From: Dominic Gothard [redacted]
Sent: 05 July 2019 13:00
To: Anita Gardner <Anita.Gardner@arun.gov.uk>
Subject: Application No. K/7/19/PL - Little Deerswood Gorse Avenue, East Preston, BN16 1SF
Importance: High

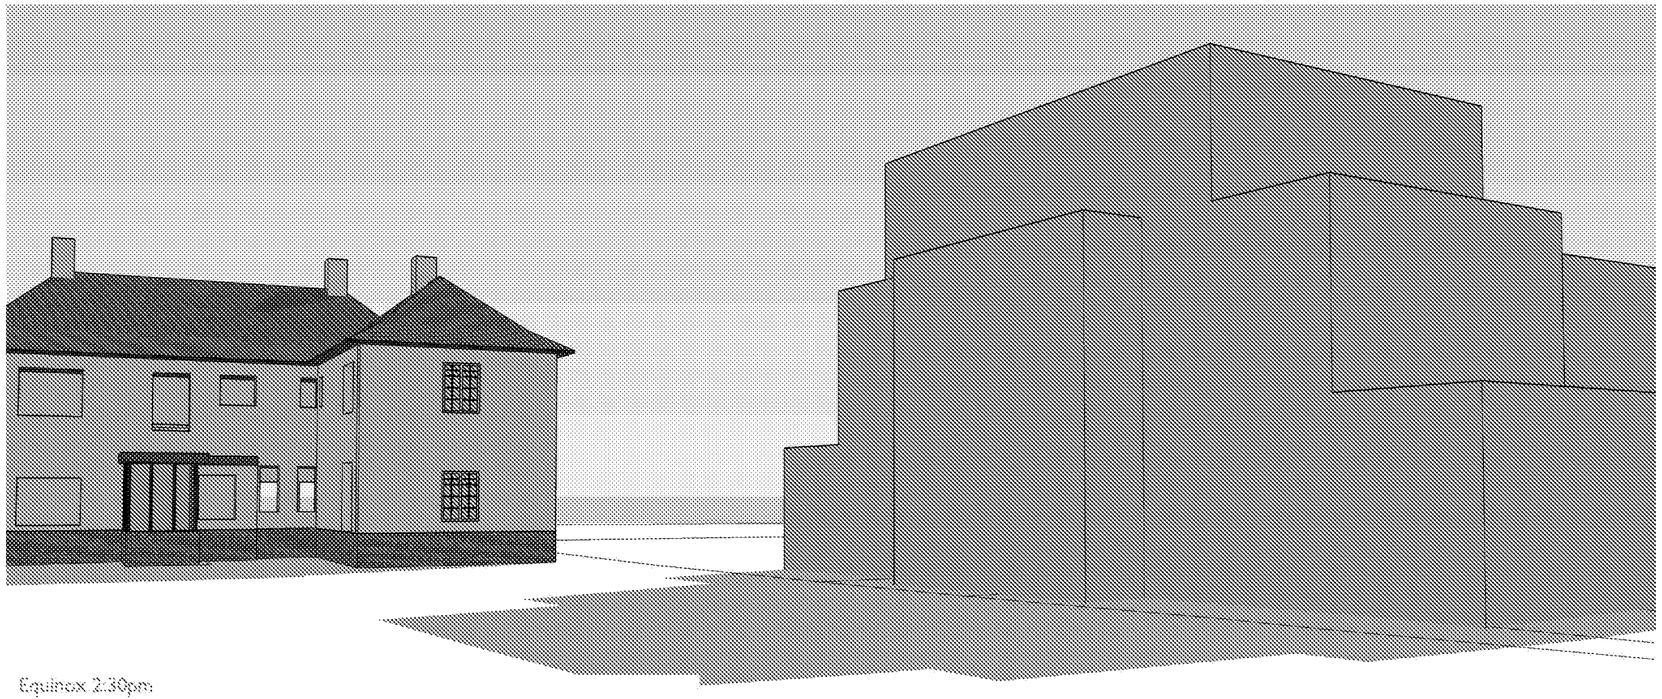
The East elevation adjacent to the boundary with Spring Tide still presents a long and sheer 3-storey form that will dominate the garden and will create an oppressively overbearing presence - the only relief being the 2 storey projection that only acts to bring the building closer to the boundary.

Equinox 2.30pm

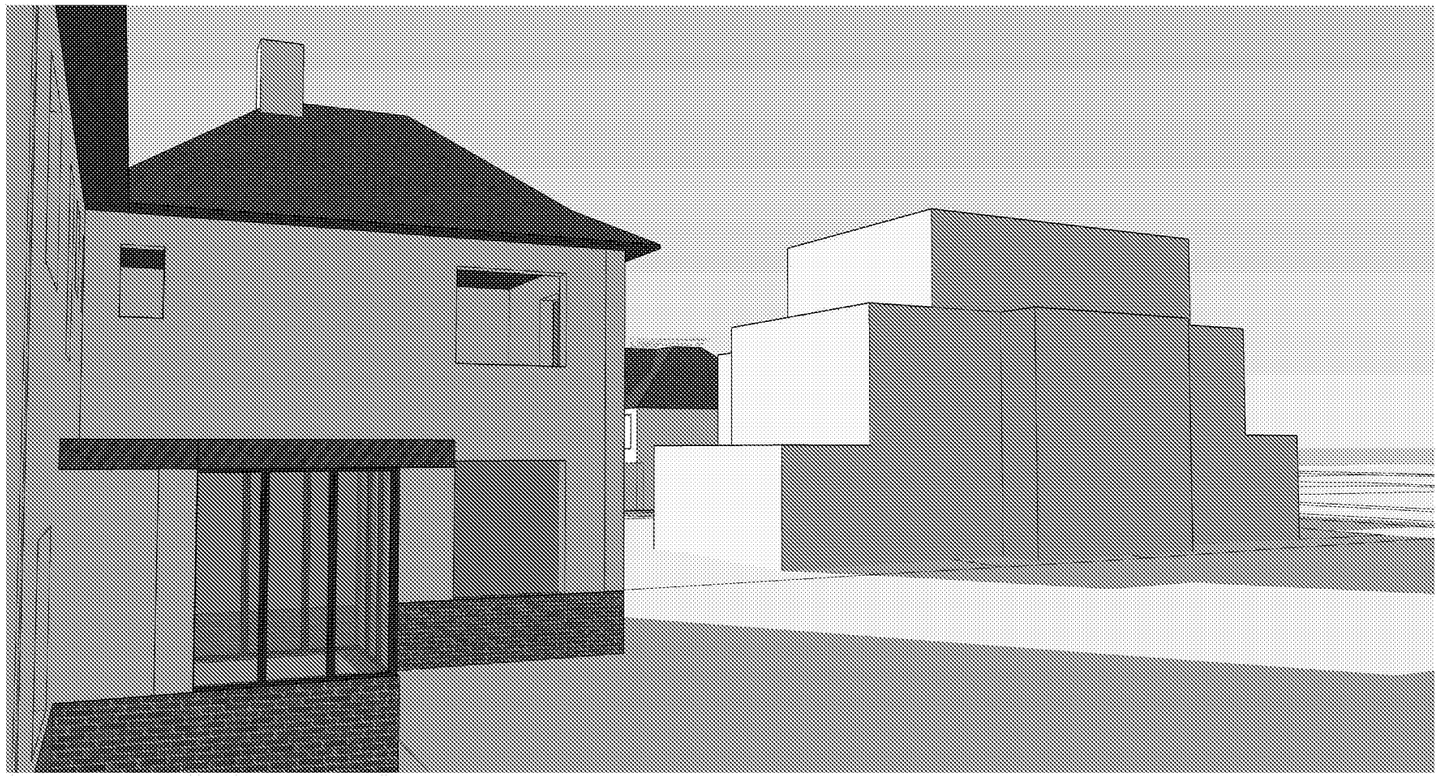
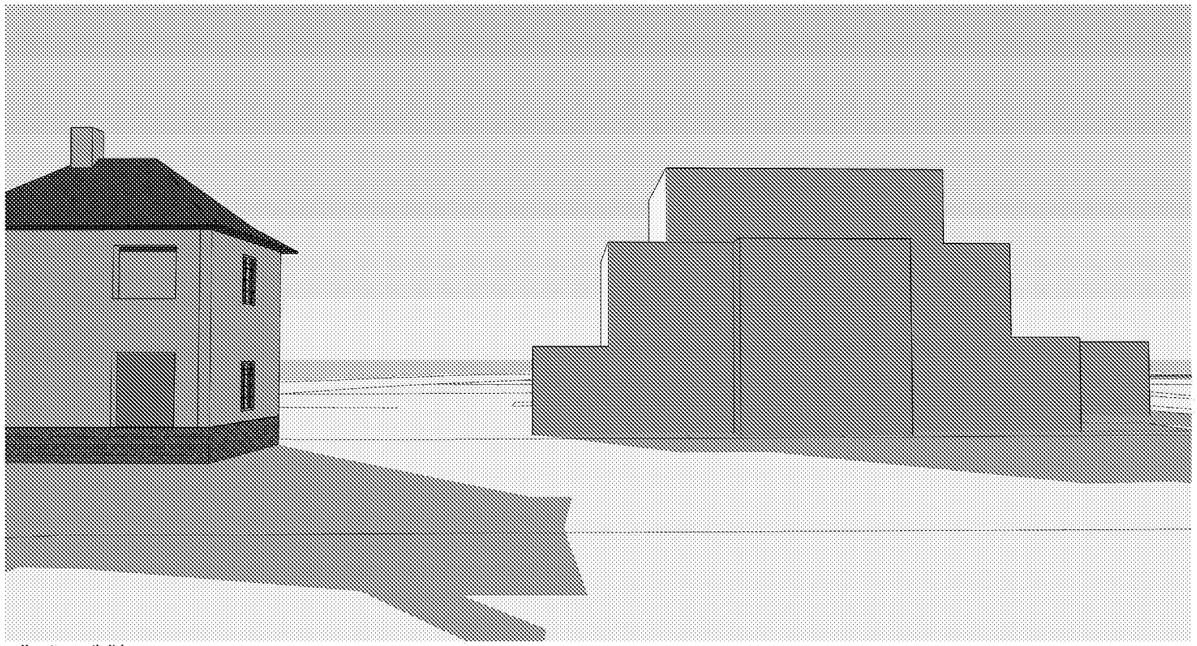
Whilst the revised design is a slight improvement on the previous scheme, it still does not acknowledge the relationship with the front garden of Spring Tide and represents a completely unacceptable form of development. The enclosed updated impact assessment drawings illustrate the impression.

WHITE HOUSE.
FOOTPRINT OF EXISTING.
1-STOREY.
3-STOREY.
1-STOREY.
2-STOREY
LITTLE PEEKWOOD.
2-STOREY
3-STOREY.
1-STOREY.
FOOTPRINT OF EXISTING
SPRING TIME.
LITTLE DEEKWOOD MASSING PROPOSAL.

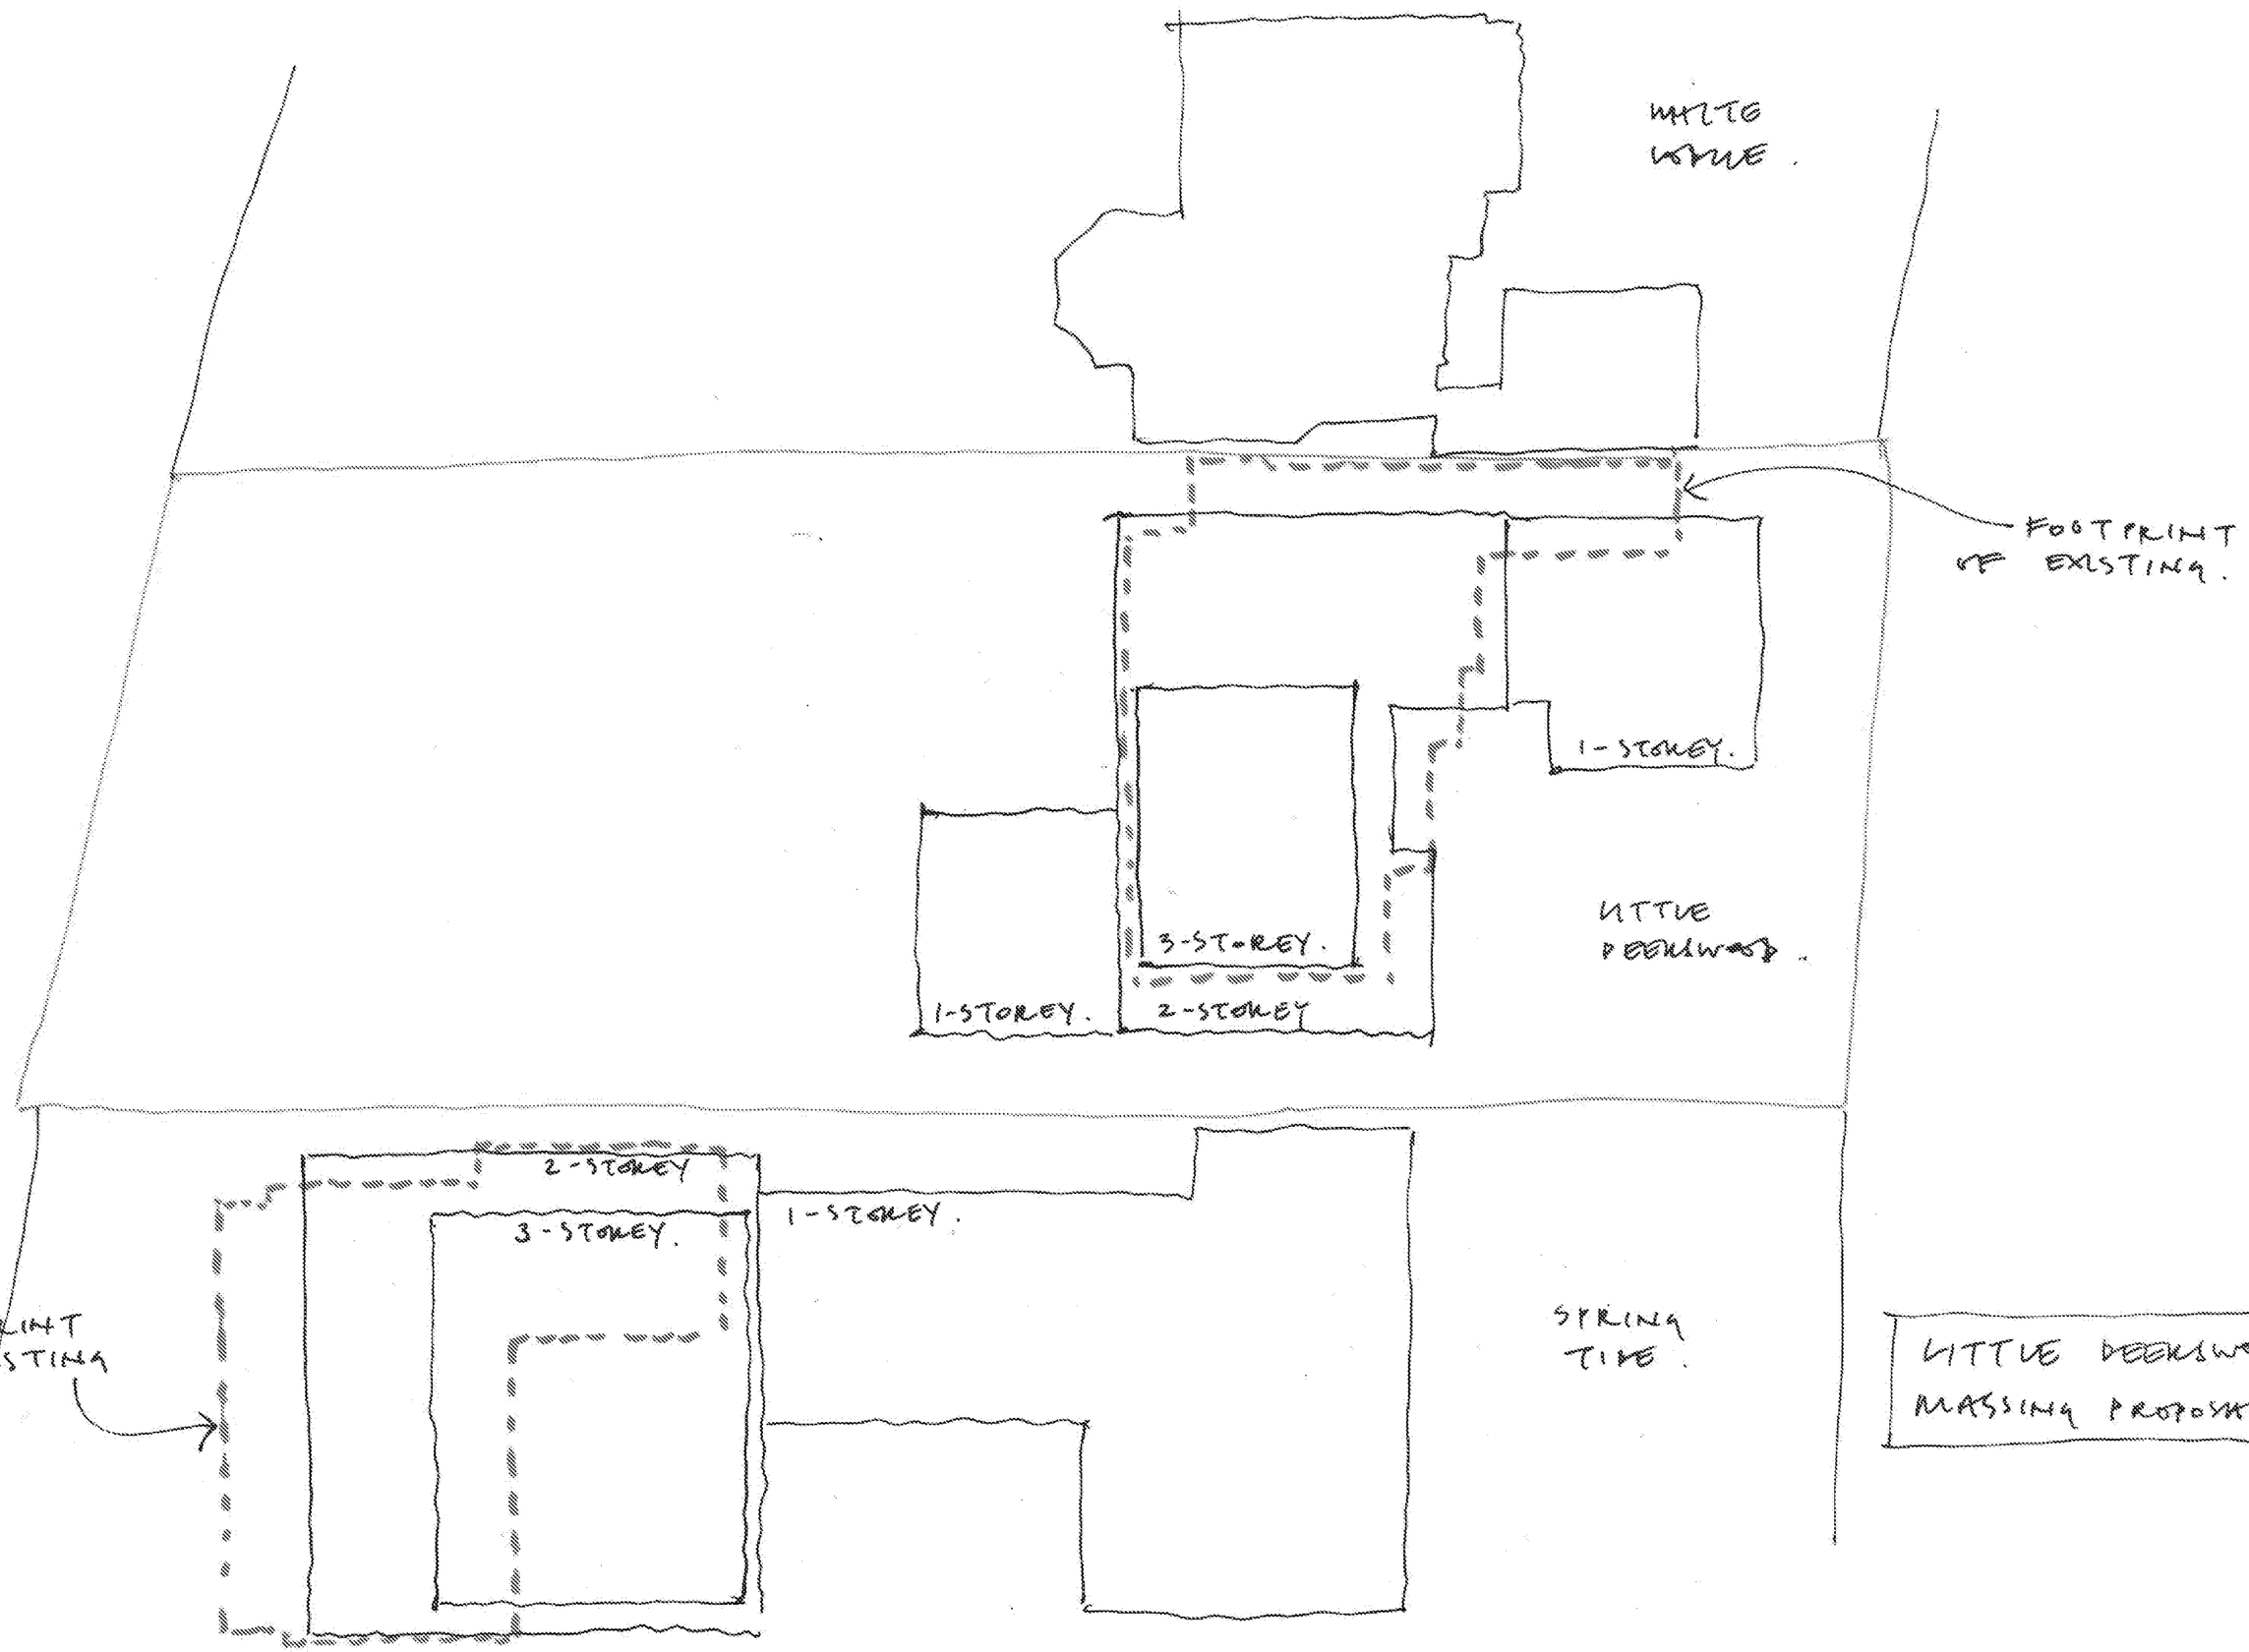
If the proposal at Little Deerswood were to follow these same principles, from our perspective it would result in an acceptable form of development. We have attached a suggested massing proposal showing how the form would evolve if it followed the principles established by the approved design at Spring Tide.
